BAR Work Session  
7/18/2016  
William Taylor Plaza Phase 2: PUD Requirement

WILLIAM TAYLOR PLAZA - RIDGE STREET PLAN  
Stoneking / von Storch Architects  
P.O. Box 1332 Charlottesville, VA 22902

SP 1

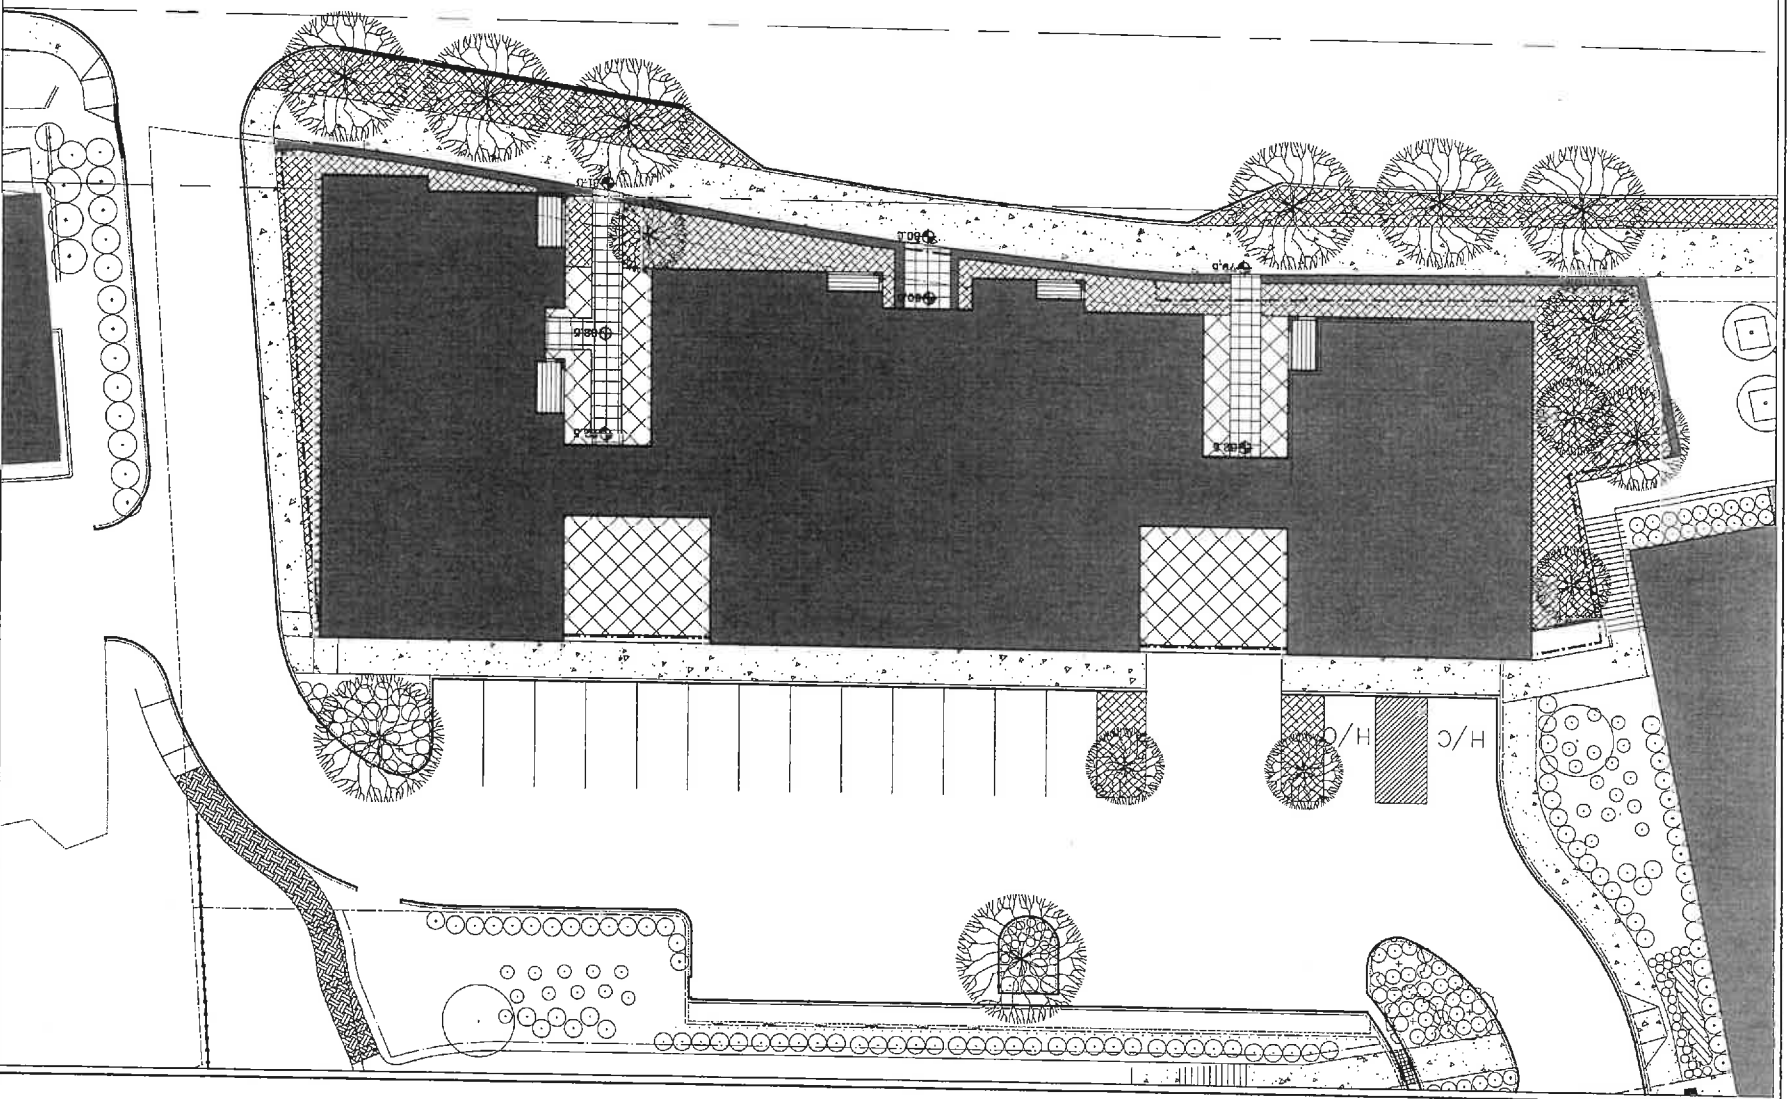
Mr. von Storck: Again here is an example of how the model has not been rendered, which makes this massing feel pretty harsh compared to the Ridge Street side. Internally we wonder if repeating the gables in this direction is helpful to the massing or not helpful. It brings the scaling of the gables around, but it makes this facing feel taller than it actually is.

Mr. Schwarz: I was just thinking is there any way that you can play with your roof line to make it appear more like it is two and a half stories, if the third story could be more roof I think that

would help with your massing. The way you are breaking up the building seems to work out well with the lot sizes, and the rhythm of sides are good, but it might be stronger the middle entryway transparent or pulled back to make it appear more like four pieces, as opposed to two house size pieces and the large middle one. The view from the south façade elevation on Ridge Street seems to not stay within the confines of the massing for the district. Marriot worked on their scale to figure out a way to make it fit within the district, and your plan just seems very tall.

Mr. Mohr: Is there any modulation possible with that south wall?

Mr. Sarafin: It strikes me that this south façade is going to be the most challenging and the most important to get right. I know this is just massing and it is a block and it is not treated architecturally here, but it can't help but underscore some of the scale issues that have been brought up. I thought the two and a half story expression might be good, I am not entirely sure that the gable form is the answer for how to treat it. And if the two and a half story versus three maybe relates better to this end of the Marriot. In any event, where this project engages with this little square, and I am aware it might not literally connect, but it is going to have to work with the corner and the Marriot. This is a very prominent approach and this is going to be really important to get that right. I don't know what the answers are, but I would encourage we look at this relationship between the Marriot on the corner and this end; it could be more jarring then the north end and the preexisting Ridge Street houses. The transition is almost the most important part of this.

Mr. Mohr: I think the scale of the windows is a bit off. It is somewhat like an apartment building, but then it has this house overlay, but the two of them aren't quite coming together. You don't have room to put porches on the front, correct? It needs something that would carry a horizontal line. It is in a funny zone where it really isn't in a house scale, and it is tall. It reads more as an apartment building, and it seems with the cut through that you are trying to make it more with the houses in the districts, is not working. It is too tall.

Mr. Mohr: You might look at something that starts to create a break in that street wall, so it feels more like it is in scale with the other houses down the street. The window arrangement and scale needs works.

Ms. Knott: I still feel very strongly about the setbacks on these buildings, they are fairly close to the streets, but this is so much more nicely modulated along the front. So that these have a much deeper setback, almost as deep as some of the buildings along the street, I would love to see you explore that a little bit more. I would like to see the setback a little more consistent with the surrounding area. I know you have tried to relate the buildings to the surrounding scale, but I think that needs a bit more attention. The guidelines state for the massing to fit within the district, and I think this building overpowers the traditional scale. All of the other structures in the district have a hierarchy of space, going from completely public to completely private, and I do not think that this building does that with the bedrooms right next to the street. It seems like a lot of thought has gone into screening bedrooms that shouldn't even be on the street, so it seems like that needs to be rethought. Although I can't tell you what to do with the interior of the building, it just seems like moving those would solve a lot of problems. I don't really see this building relating to the historic district.

Ms. Earnst: The first thing that hit me when I looked at these was the elevation at Cherry and Ridge, that intersection just hits you hard. I think that is probably where the most work will be useful. That being said, I think the north side works a lot better. I am a little bit worried about that flat roof in between the two gables there, I don't know how visible that is from the road, but it just looks really out of place. The only other thought I had was if it would help to vary the roof line with the road [referring to Cherry].

Mr. Von Storck: Plus or minus, from the sidewalk to the midpoint of the gable is 35 feet.

Mr. Von Storck: I think once you are committed to slopped roof and gables, this is pretty much the roof line you get. We can certainly explore to see if some of the gables can come to a hipped roofed and pullback on some of that apparent height.

Mr. Von Stork: It is something we can work on. As I said we were wondering internally if it was counterproductive to express these gables. It is really a three story building adjacent to another three story building, it is just the other building is the flat hotel style construction.

Mr. Von Stork: Yes, we are not against the property line, set back, or building code.

Mr. Von Stork: We have been thinking about the possibility of peeling away a one and a half story layer, forward to the street, so there is a completely different shifted scale here that is more like a court scale and then having these windows sit a foot and a half back through that layer, as a way to change the scale and add some depth to that façade.

Mr. Von Stork: I think that falls into exploring the half story option.
